**SUPPLEMENTAL GEOTECHNICAL  
REPORT**

**GEOTECHNICAL REVIEW COMMENTS**

**HIGHLAND ESTATES**

Subject: **HIGHLAND ESTATES**  
San Mateo County, California  
**SUPPLEMENTAL GEOTECHNICAL INVESTIGATION**  
Responding to Geotechnical Review Comments

VIEWS OF TP-7 VICINITY	FIGURE: <b>A</b>	SOIL FOUNDATION SYSTEMS INC.
	DATE: 11-94	JOB NUMBER: S24-634-2S

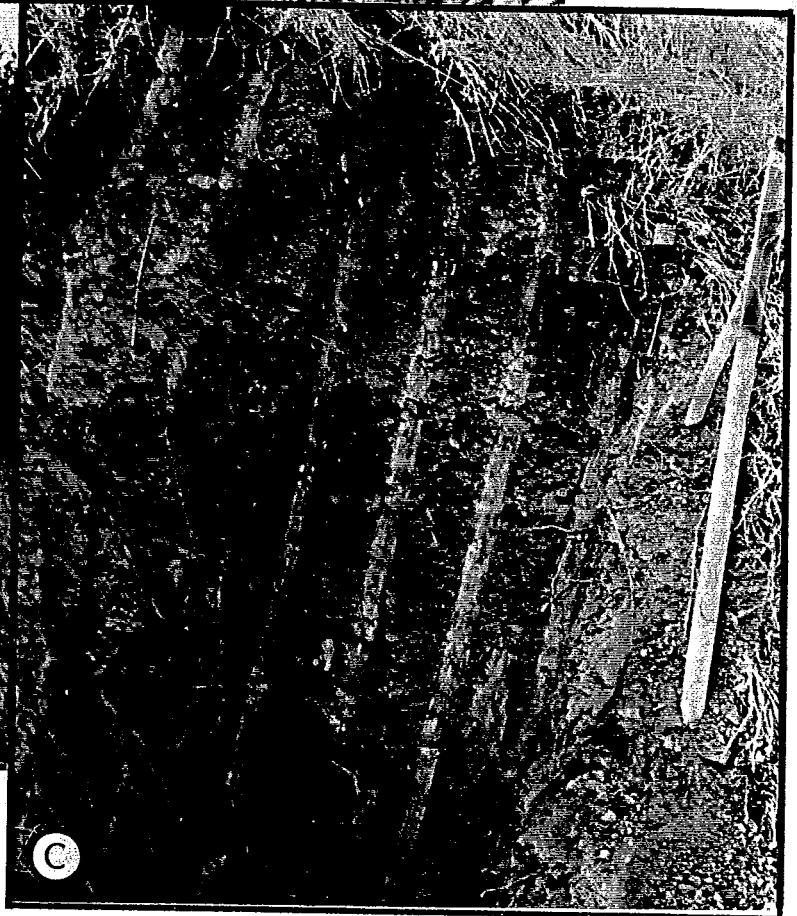
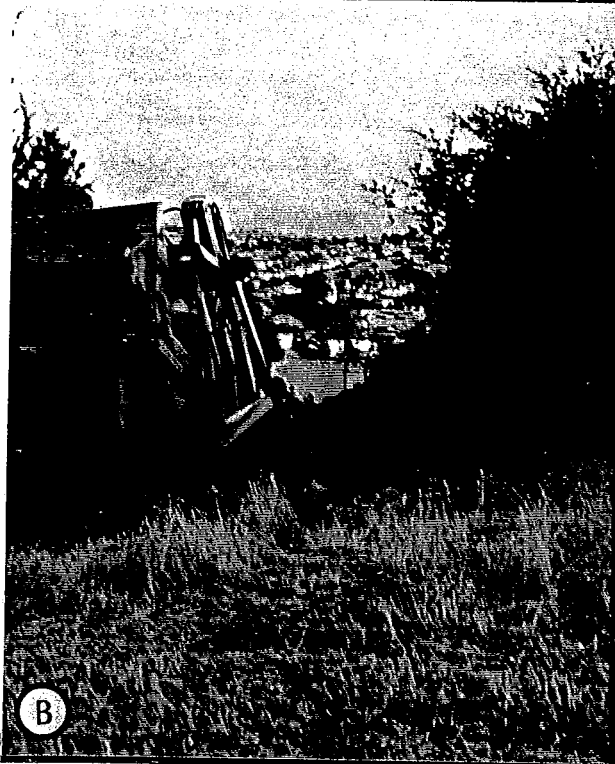
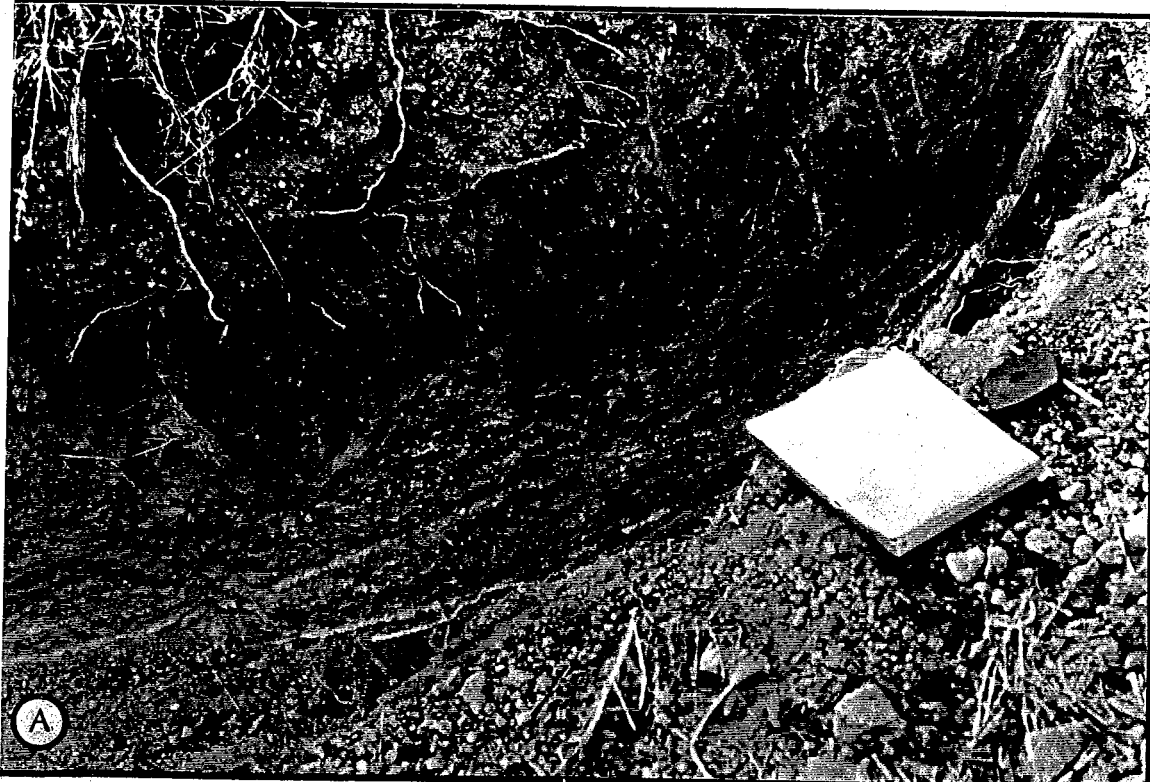
- b) *The geomorphic features on Lots 1 through 4 at the south side of Bunker Hill Drive suggest that the colluvium (Qc) and melange (Fm) mapped at that location may be landslide deposits and/or a denuded landslide scarp. The area that includes the four lots is mapped as possible landslide deposits by San Mateo County (1975) and as "unstable" by Nilsen et al. (1979), as shown on Figure 3 in the SFS report. Further subsurface exploration is recommended in this area in order to further characterize the materials and evaluate their stability. This area may include landslide deposits similar to those mapped adjacent to Lot 4.*

- b) Lots 1 through 4 are on the flank of a ridge underlain by competent graywacke sandstone bedrock. Bunker Hill Drive is aligned along the axis of the ridge. This ridge was graded to create nearly level building pads on each flank of the road, and the entire neighborhood was developed in the late 1950s. The area encompassing Lots 1 through 4 was not developed then because it was not practical to create level pad lots having sufficient depth to accommodate the Eichler house plans. Based on interpretation of geomorphic features, reconnaissance mapping, and limited subsurface data (Boring P-6), this area was considered to be underlain by graywacke sandstone at a shallow depth. There is a well-defined drainage swale on Lots 2 and 3. It is overgrown with native vegetation and appears stable; however, Plates 1 and 2 show colluvium (Qc) in the axis of the swale. It is our conclusion that the depth to bedrock is greater than five feet in this area.

In response to ESC's concerns regarding stability in this area, subsurface work was performed in this portion of the site as a part of the supplemental investigation. Test Pit TP-7 was excavated on proposed Lot 1, and a Minuteman boring (BS-2) was situated in the axis of the swale, near the south corner of proposed Lot 3. The test pit, which was excavated on an existing bench, penetrated graywacke sandstone that was so massive that the test pit was only excavated to a depth of 2.5 feet deep. A graded, six-foot high slope above the bench was exposed in the back wall of the test pit. It exposed six feet of stiff fill. The bedrock on the floor of TP-7 was more difficult to rip than materials logged elsewhere on the site. Plate C in Section A of the Appendix presents the log of TP-7 and Figure A, page 12, presents views of field conditions. View A shows the contact of the slightly weathered (gray) sandstone on the lower part of the trench wall. Overlying the gray sandstone is a moderately weathered (yellowish brown) sandstone. View B shows the backhoe exiting the site. In the foreground is the upper graded pad. The backhoe used an existing haul road to access the lower bench. View C shows the stiff, rocky fill exposed in the back wall of the trench. The lath to the right of the trench is three feet long.

SEISMICITY OF CALIFORNIA, 1808-1987	FIGURE: <b>B</b>	SOIL FOUNDATION SYSTEMS INC.
	DATE: 11-94	JOB NUMBER: S24-634-2S

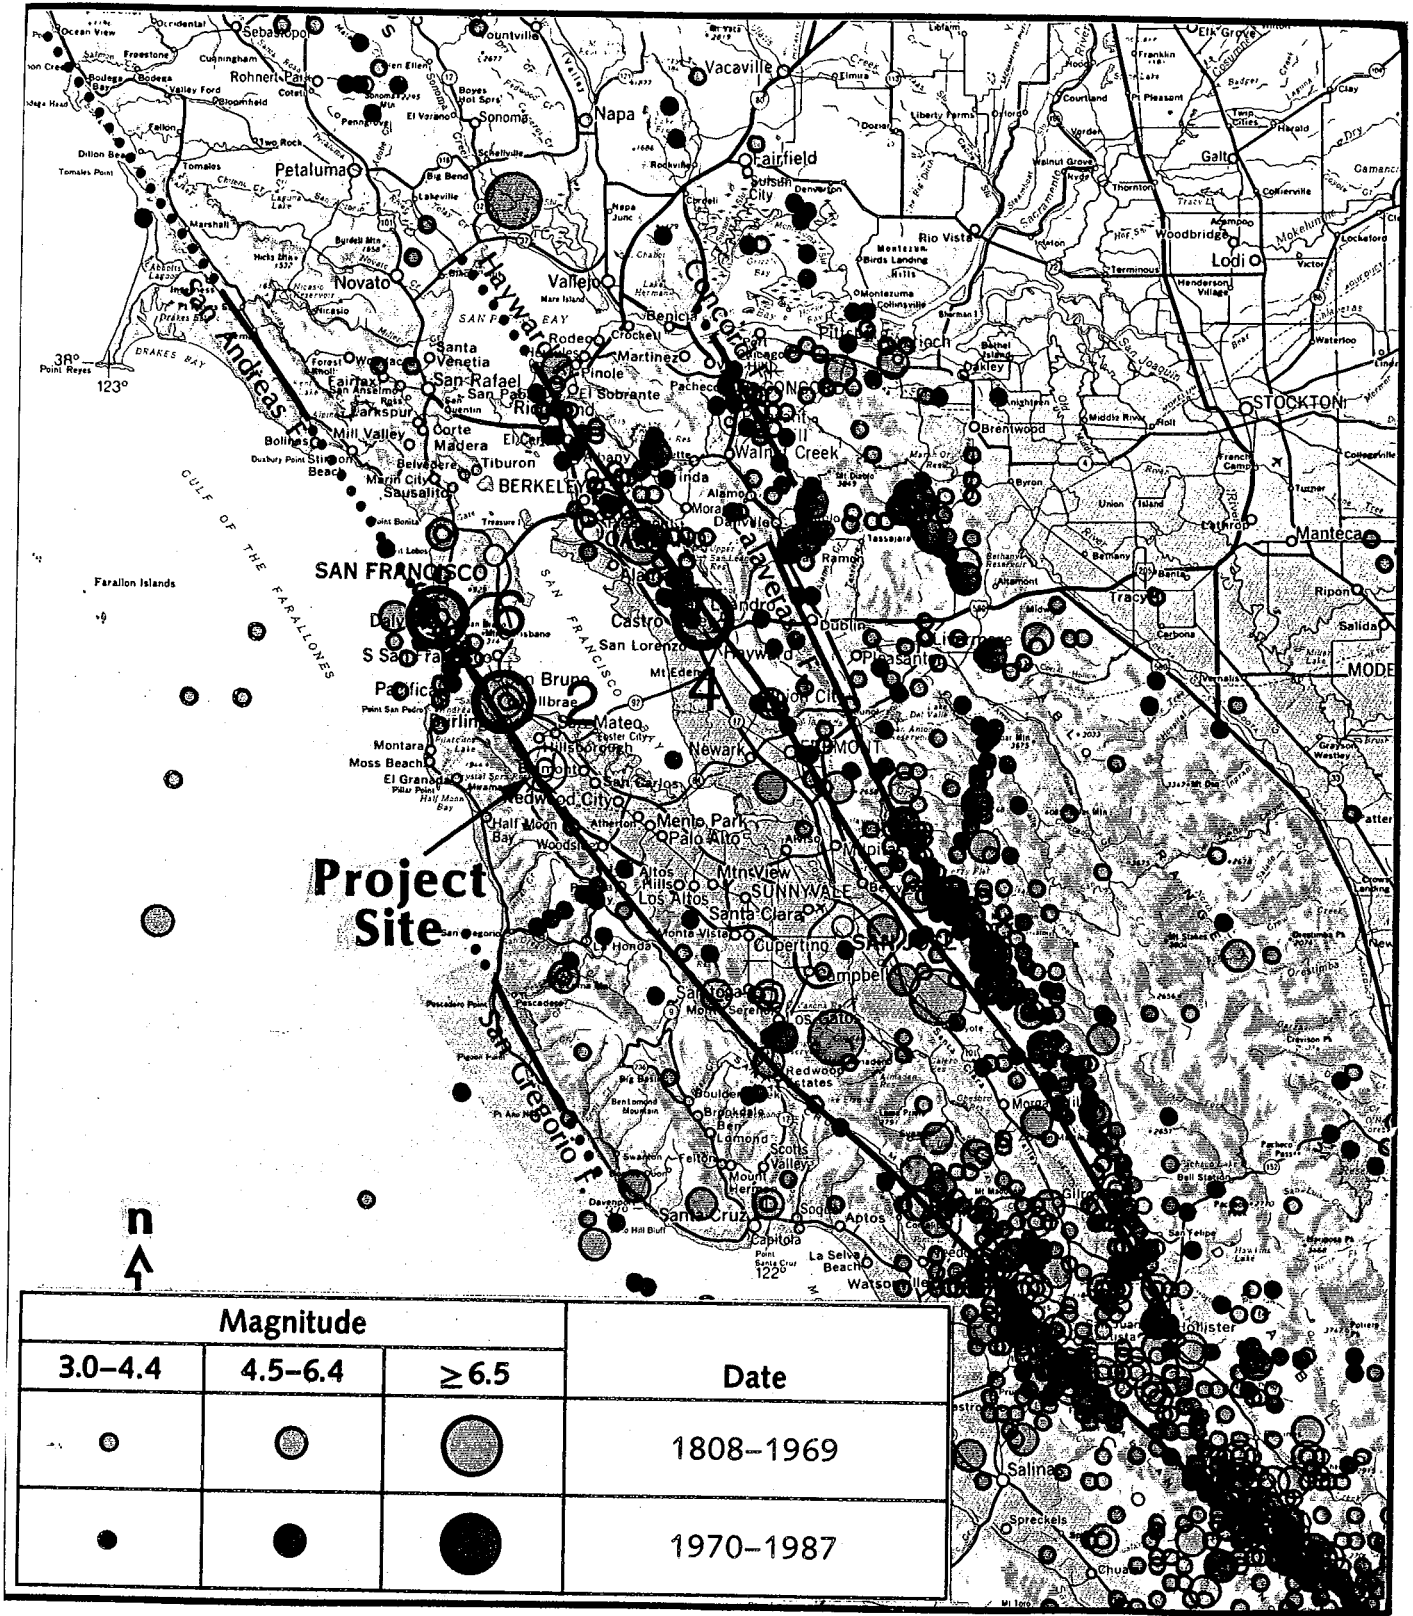
- b) A discussion of historical earthquakes and their effects on this or similar nearby sites should be included in the report. Figure 4 in the SFS report indicates that the site area would experience ground shaking intensities of Modified Mercalli 6.5 (sic) for a 1906-type event (M 8.3) on the San Andreas fault. Other references suggest higher ground shaking intensities, and they should be presented for comparison. For example, Nason (1980) reports a Modified Mercalli intensity VIII during the 1906 earthquake for the San Mateo Hills at a location 3 km east of the San Andreas fault. Borchardt and others (1975) predict that the site area will experience "very strong" ground shaking in a 1906-type earthquake. This corresponds to Grade C on the San Francisco intensity scale, which is comparable to intensity 8+ on the Rossi-Forel scale, and intensity VIII on the Modified Mercalli scale.*

- c) The SFS report cites a peak ground acceleration of 0.5g for a magnitude 7 earthquake on the San Andreas fault, based on attenuation curves by Seed and Idriss (1982). Data from the Loma Prieta Earthquake of 1989 (M 7.1) indicate a peak acceleration of 0.64g at Corralitos, approximately 6.5 miles from the earthquake epicenter (CSMIP, 1989). The report should also discuss predicted peak accelerations for a magnitude 8 to 8.3 event on the San Andreas fault. Several other references are available for estimating peak horizontal accelerations, both for near-field and distant earthquakes. (See 1992 CDMG Open File Report 91-1, "Peak Acceleration from Maximum Credible Earthquakes in California", among others.) The implications of higher peak accelerations should be discussed by the consultant.*

- a) Enclosed with this response document is a regional seismicity map which shows the location of the site in relationship to earthquake epicenters and faults (see Figure B, page 20).
- b) Notable San Francisco Bay Region earthquakes include the following:

report, the Pulgas Hill area, including this site, is in an area subject to "strong" earthquake shaking (San Francisco Intensity D). This correlates with a Modified Mercalli intensity of VII. The damage cost factor for Class 1A buildings (wood-frame dwellings) is 5% at San Francisco Intensity D. Therefore, a residence with a replacement cost of \$300,000 could expect to sustain an average cost of \$15,000 in earthquake damage. In the event of ground failure or fire, the damage could be more severe. If maximum ground shaking intensities on the site are Modified Mercalli VIII as is suggested by some of the references cited by ESC, the damage cost factor would be 7% for wood-frame dwellings, and a structure valued at \$300,000 could expect to sustain, on average, \$21,000 in damage.

Figure D - Index Plan of Townhome Development

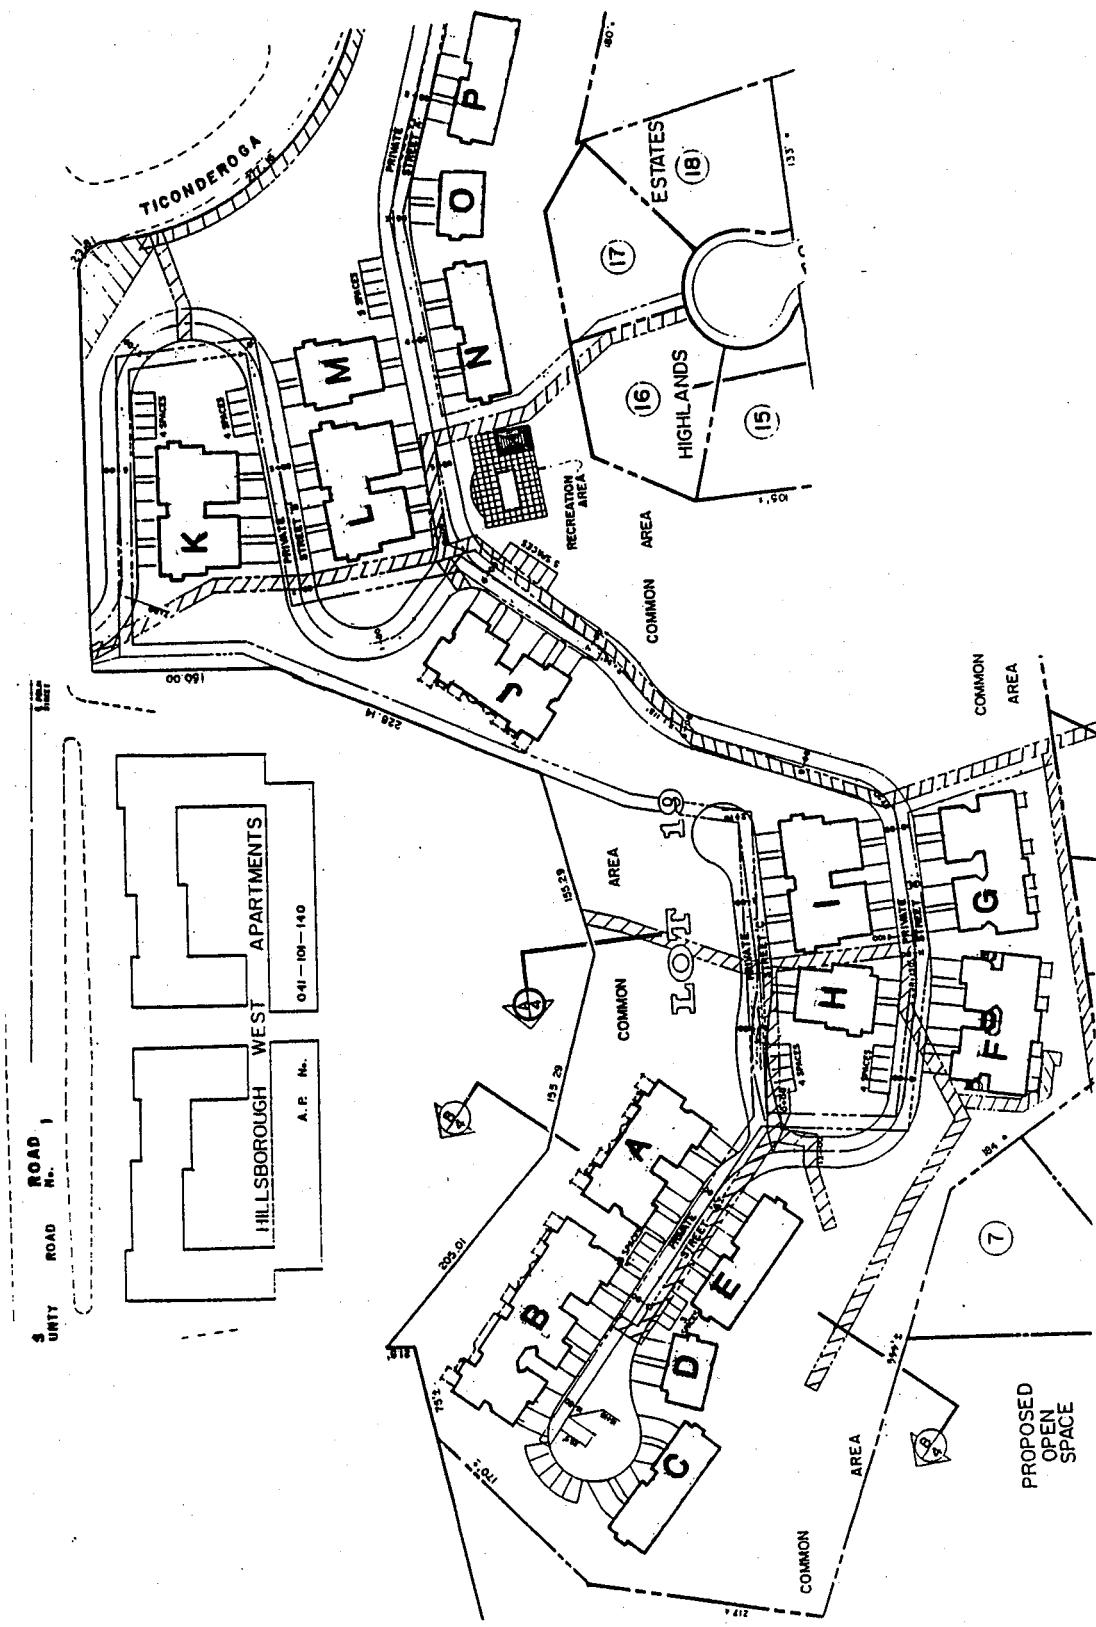
*Potential for settlement of buildings and other improvements requires further evaluation and discussion due to the large thickness of fill planned over the moderately compressible alluvium west of the Hillsborough West Apartments (Section GS-4) and the planned varying thickness of fill under some buildings. The report should include a discussion of the potential for hydrocompression of fill after construction improvements. Delaying construction until after the first winter may not be long enough under extreme fill conditions.*

Critical buildings were selected based on the amount and thickness variation of fills under each building. Figure D is an index plan showing designation of the buildings in the townhome area. Table S-I presents the maximum thickness of underlying fill and the ratio of differential fill thickness to horizontal distance for each building.
